ADEQUACY OF STATION ELECTRIC DISTRIBUTION SYSTEM
VOLTAGES, FORT CALHOUN STATION

ADEQUACY OF STATION ELECTRIC DISTRIBUTION SYSTEM VOLTAGES
FORT CALHOUN STATION

Responsible NRC Individual and Division
J. Emami/Division of Systems Integration
J. Donohew/Division of Licensing
Docket No. 50-285
TAC No. 12738

This EG&G Idaho, Inc., report provides a review of the capacity and the capability of the onsite distribution system at the Fort Calhoun Station, in conjunction with the offsite power sources, to automatically start and continuously operate all required safety loads.

Figure 1. Fort Calhoun unit single-line diagram.

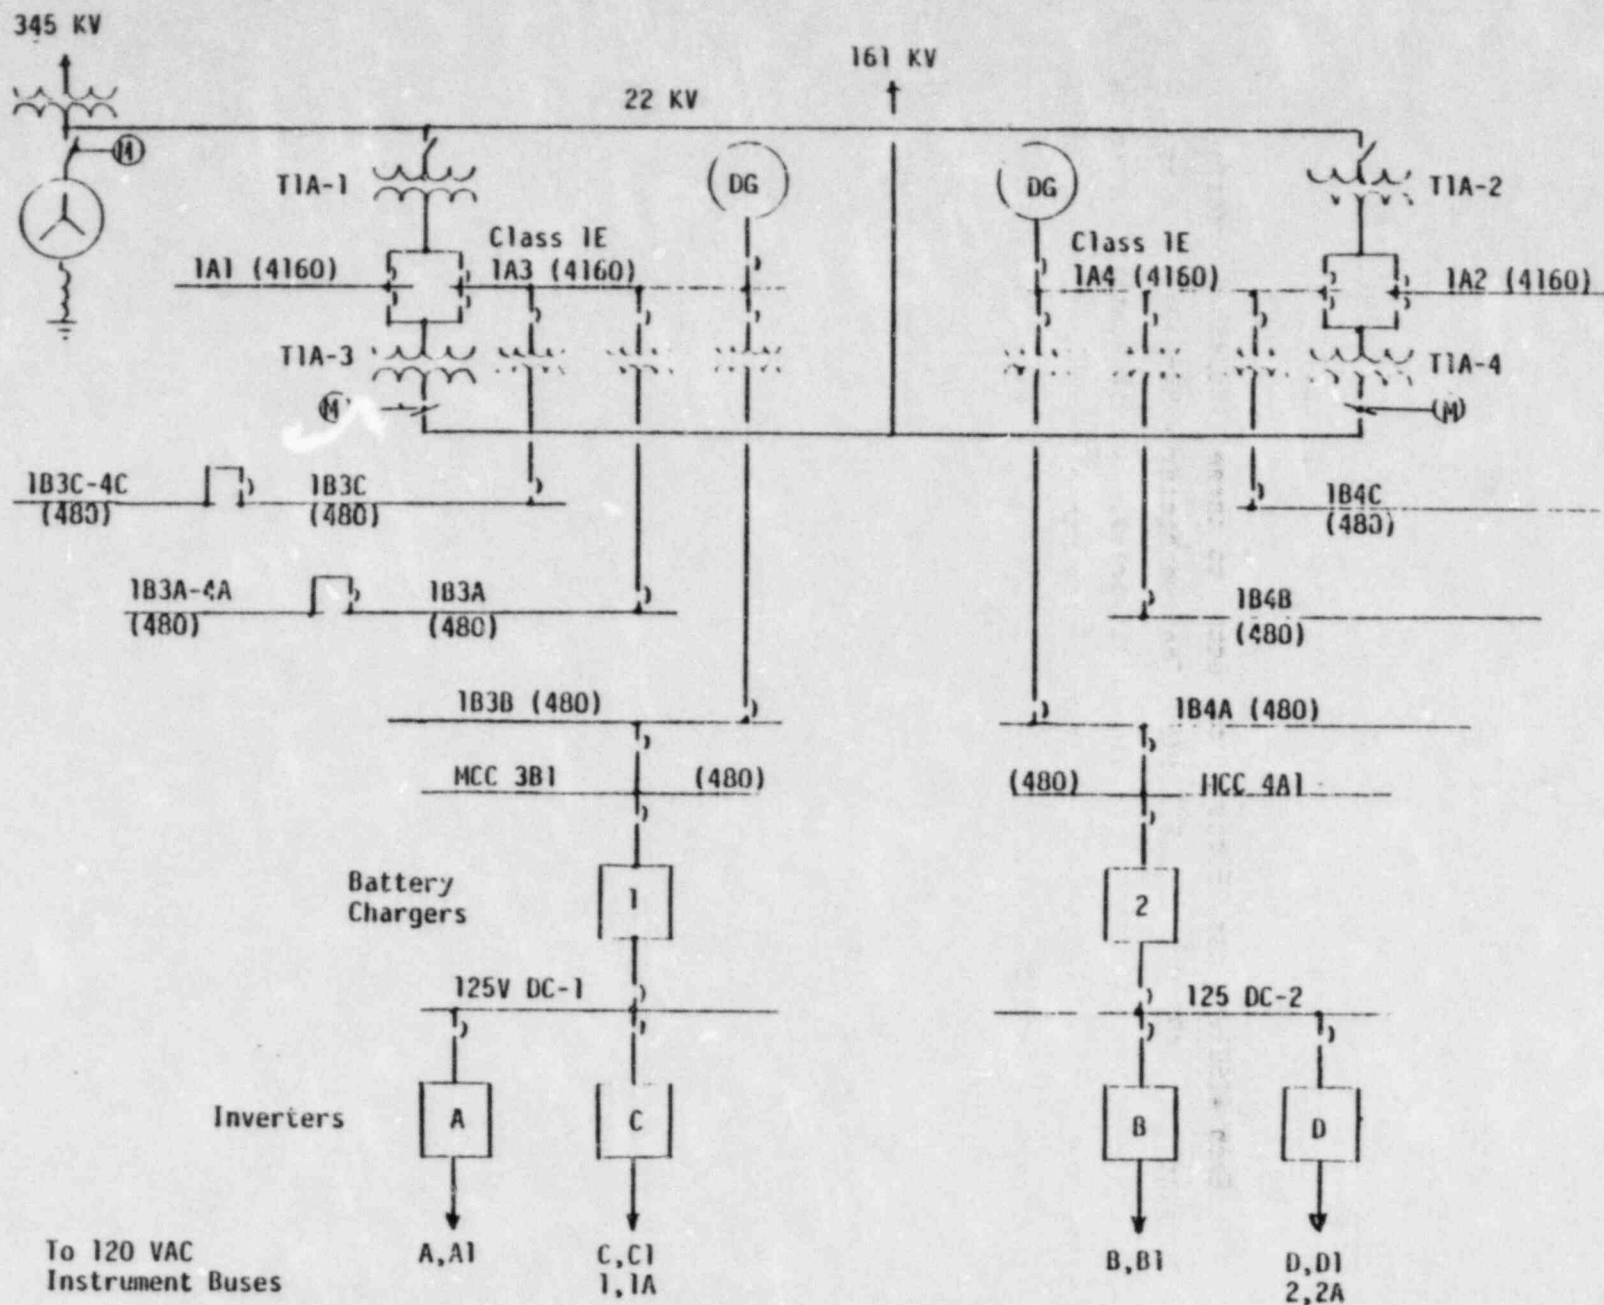
Figure 1 of this report is a simplified sketch of the Fort Calhoun electrical single-line diagram. Generator Auxiliary Transformers T1A-1 and T1A-2 are normally fed from the main generator. With the main generator disconnected (by a motor-operated disconnect switch), these transformers can also be backfed by the main transformer from the 345 kV grid. Station Auxiliary Transformers T1A-3 and T1A-4 are connected to the 161 kV grid. Any two of these four transformers are rated as capable of

supplying the total unit auxiliary load. Automatic fast transfers are provided to switch the power source from the generator auxiliary transformers to the station auxiliary transformers.

Should offsite power fail, two emergency diesel generators are available. These are automatically started and loaded by the Class 1E distribution system. These diesels are each maintained in a warm standby condition and have independent air start and closed cooling water systems.

Each 4160 V Class 1E bus is connected to three 4160/480 V transformers to supply the 480 V Class 1E loads. The two battery chargers shown on Figure 1 supply the unit dc buses and batteries. A third battery charger, not shown, is available should either of the other two be out of service. The two dc buses power four inverter fed 120 V ac instrument buses.
